# Technical News

Ref. No.	Issuer company	Issue (yyyy/mm/dd)	Last modification (yyyy/mm/dd)
PV21-DSC501	IPS(DI)	2021/04/20	2021/08/18
<b>Subject</b>			
<b>Operation change for Audio IC change</b>			
Model (System model)	Destination	Serial number	Color
ZV-1	All	All ~ All	All

**Old type**  
Adjustment

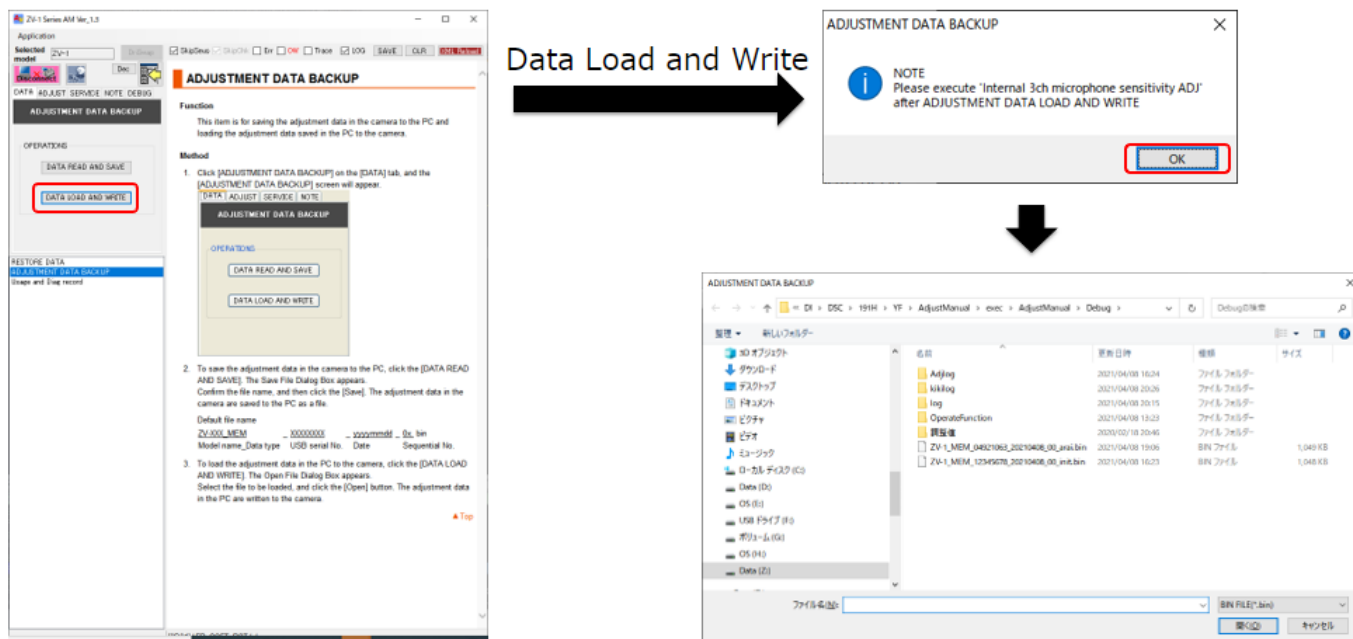
- For new Audio IC, Internal 3ch microphone sensitivity ADJ will be changed to fixed value input.

**New type**  
Fixed data input
